Committee to Minimize Toxic Waste

January 3, 2008

Subject: Comments on the Draft Environmental Impact Report (DEIR) for the Construction and Operation of the Computational Research and Theory (CRT) Facility at the Lawrence Berkeley National Laboratory (LBNL) site.

FIGURE 2. LBNL SITE MAP, GROUNDWATER CONTAMINATION PLUMES AND CONTAMINATED SOIL SITES.

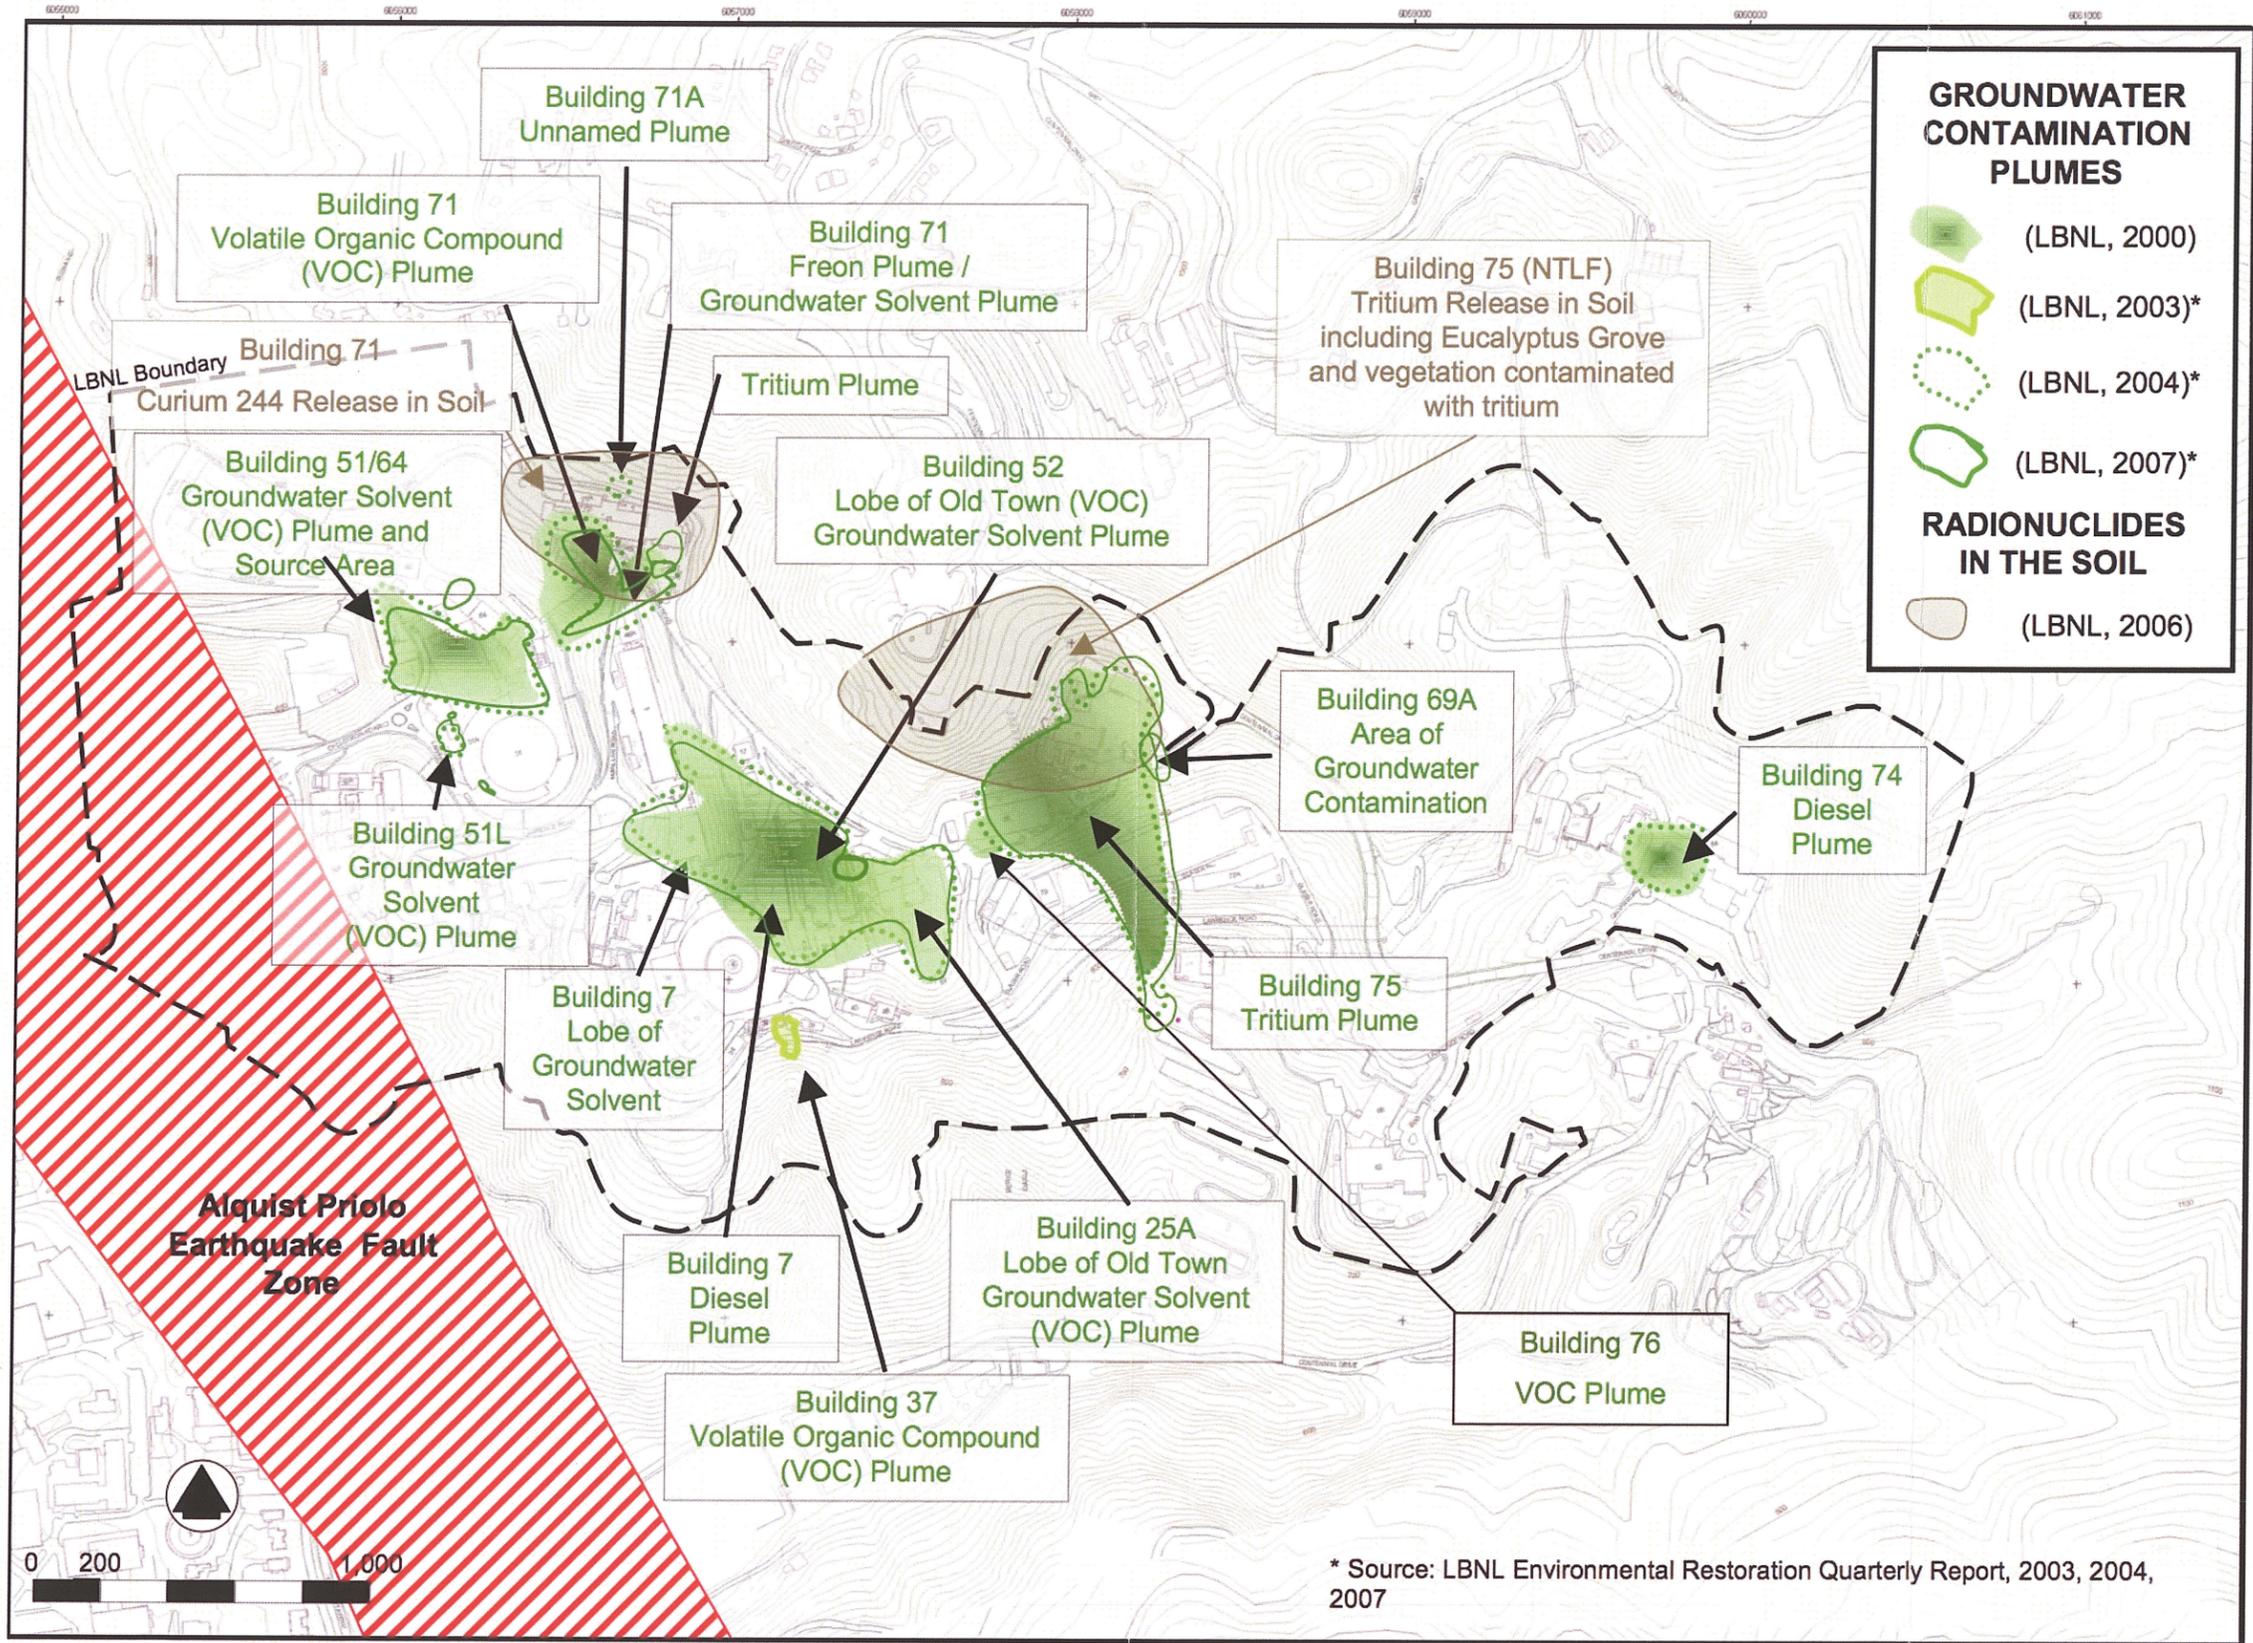
We ask that the Report text and maps be included in their entirety (as hard copies and maps in color) as part of the CRT Final EIR, and responded to. In addition we are providing 13 Report maps, 11"x17" in full color, titled: LBNL SITE MAP, groundwater contamination plumes and contaminated soil sites (F2), INTERPRETATION OF HISTORIC CHANNEL NETWORK at LBNL in Strawberry Creek Watershed (F5), GROUNDWATER CONTAMINATION PLUMES IN RELATION TO THE MODERN AND HISTORIC DRAINAGE NETWORKS AT LBNL (F6), SELECTED EXAMPLES OF FAULT MAPPING STUDIES AT LBNL IN STRAWBERRY CANYON (F9), COMPILATION OF FAULT MAPPING at LBNL in Strawberry Canyon relative to soil and groundwater contaminant plumes(F10).

FIGURE 12b. GROUNDWATER CONTAMINATION PLUMES AND RADIOACTIVE CONTAMINATION IN SOIL RELATIVE TO FAULTS AND EARTHQUAKE EPICENTERS AT LBNL IN STRAWBERRY CANYON

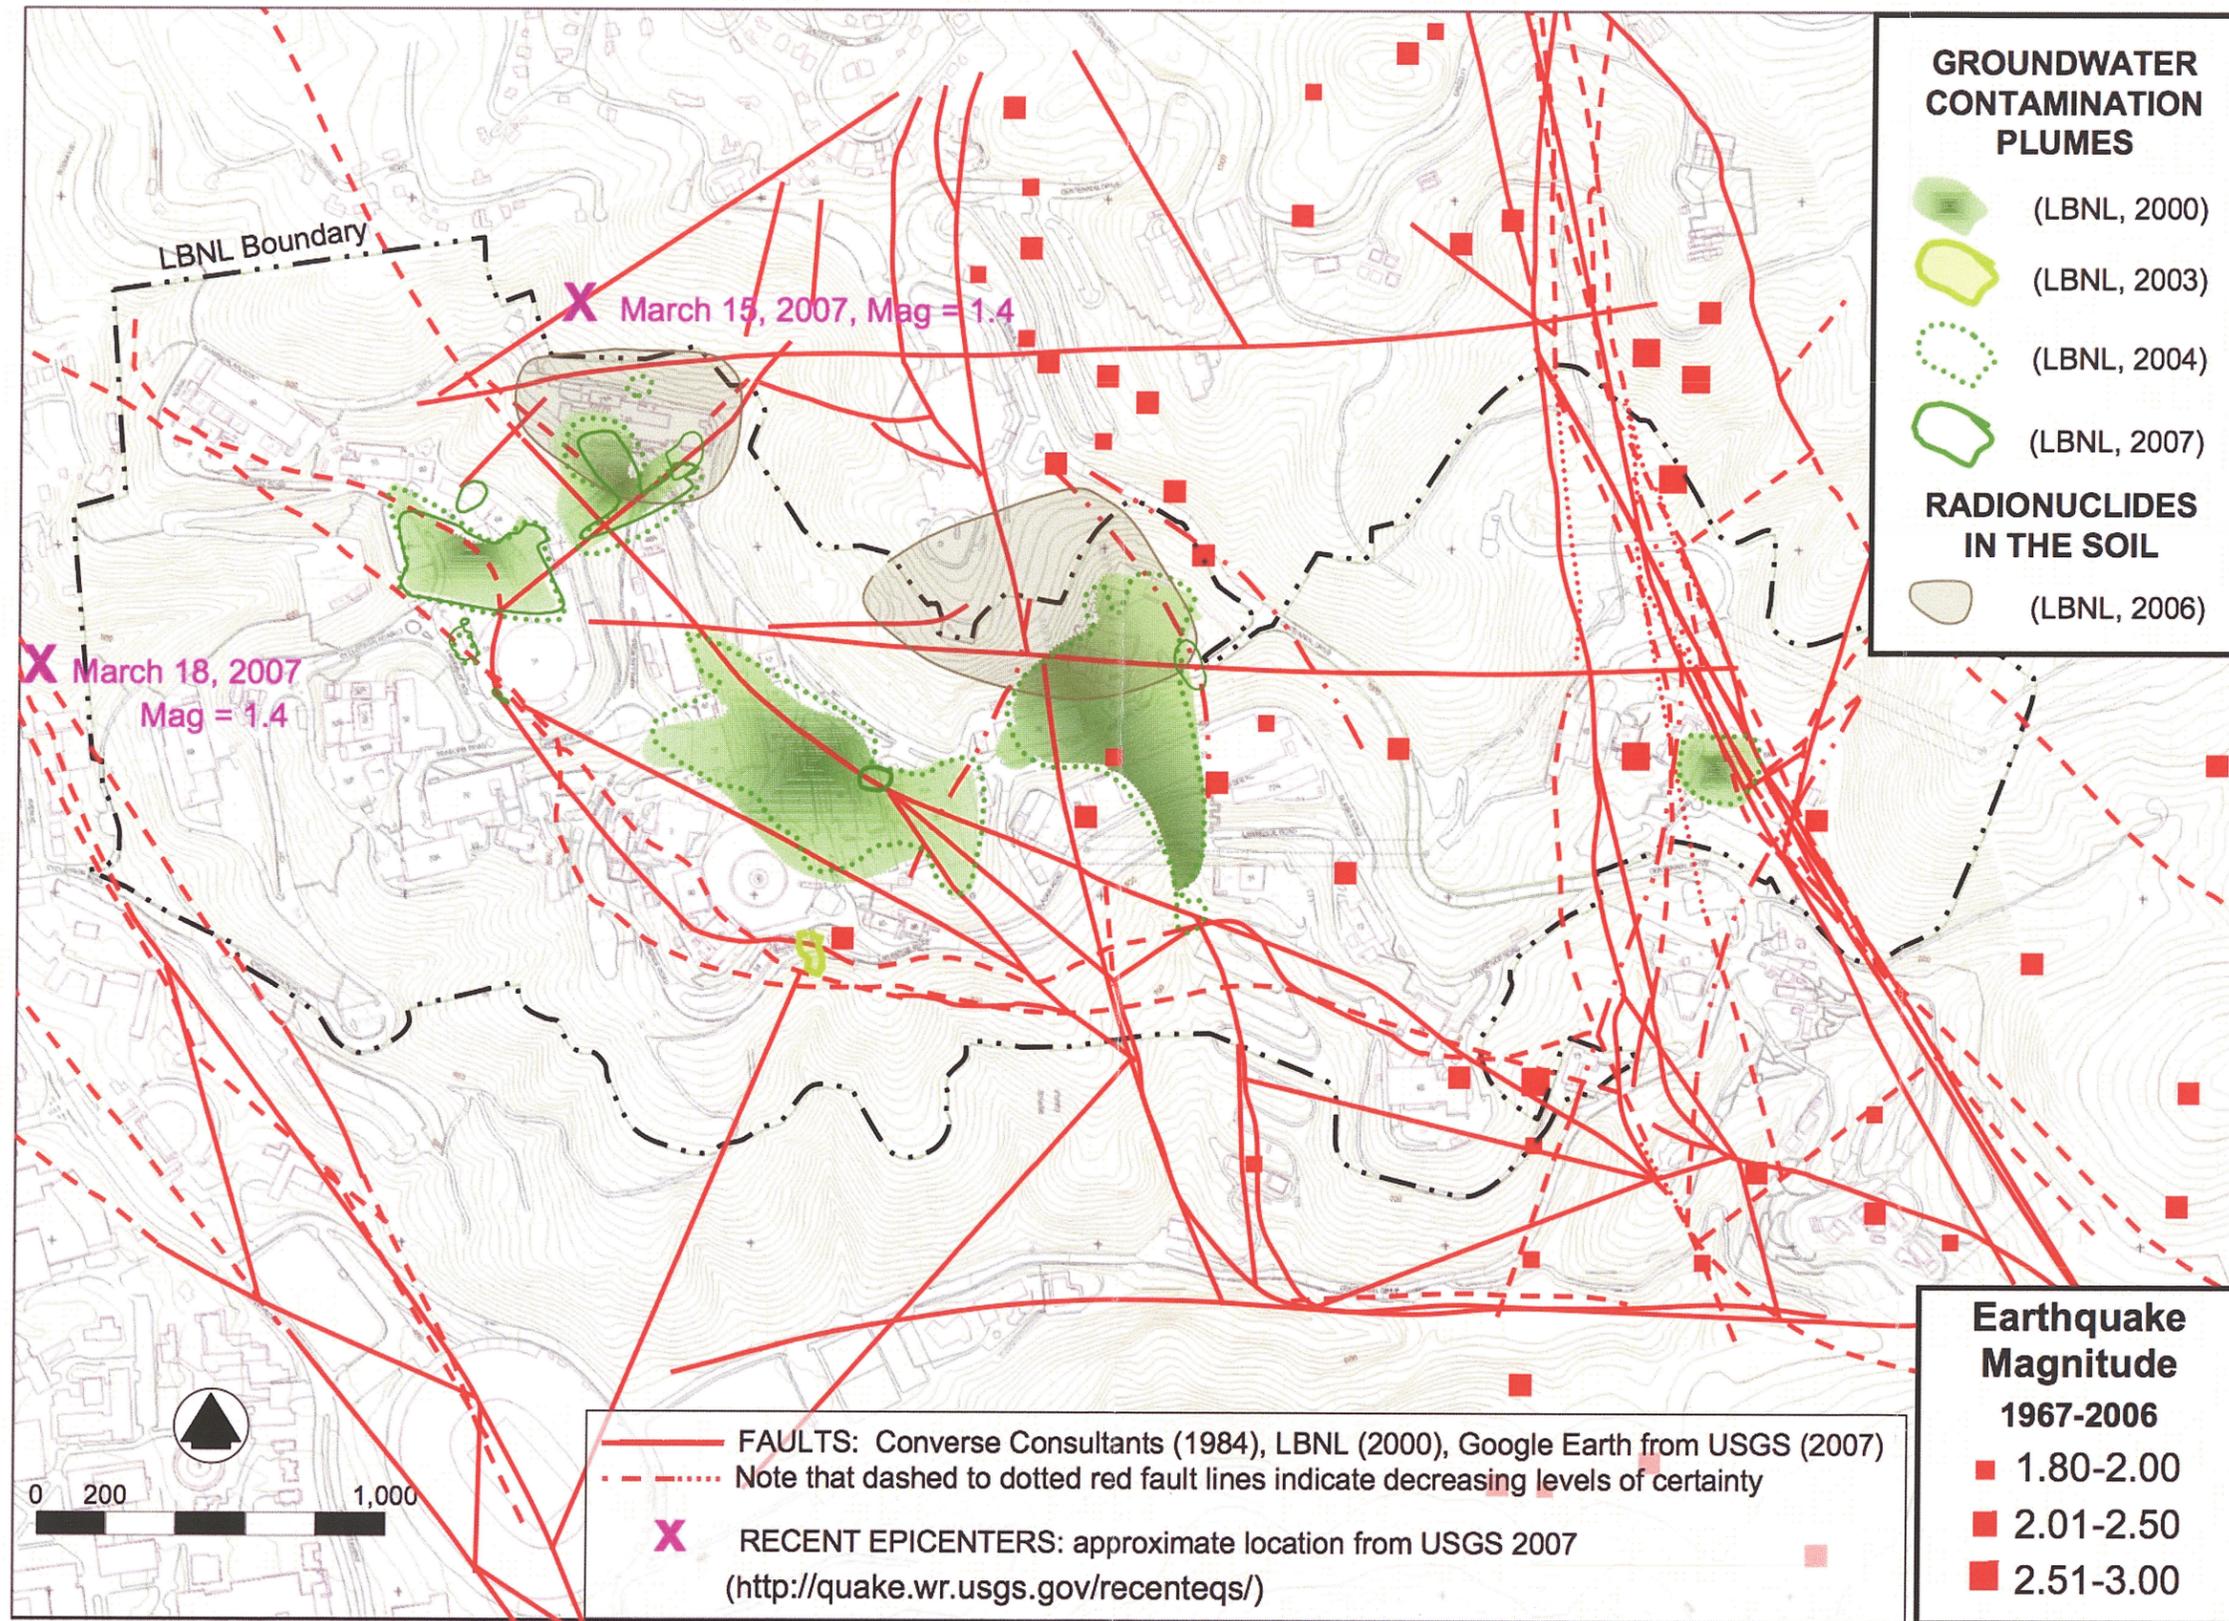
Of special interest is map titled:
GROUNDWATER CONTAMINATION PLUMES AND RADIOACTIVE CONTAMINATION
IN SOIL RELATIVE TO FAULTS AND EARTHQUAKE EPICENTERS AT LBNL IN
STRAWBERRY CANYON (F12b).

In Figures 12a and b we compiled the fault mapping by others (See Figure 9) and overlaid the epicenters of seismic events that have occurred in the Strawberry Canyon during the last 40 years, which amounted to over 57 earthquakes. Such a high incidence of seismic activity within the mapped traces of Wildcat Fault and between the Wildcat and the Cyclotron Faults provides compelling evidence that additional faults, other than just the Hayward Fault should be considered ACTIVE in Strawberry Canyon. See section on Fault Mapping on pages 24-35 of the Report.
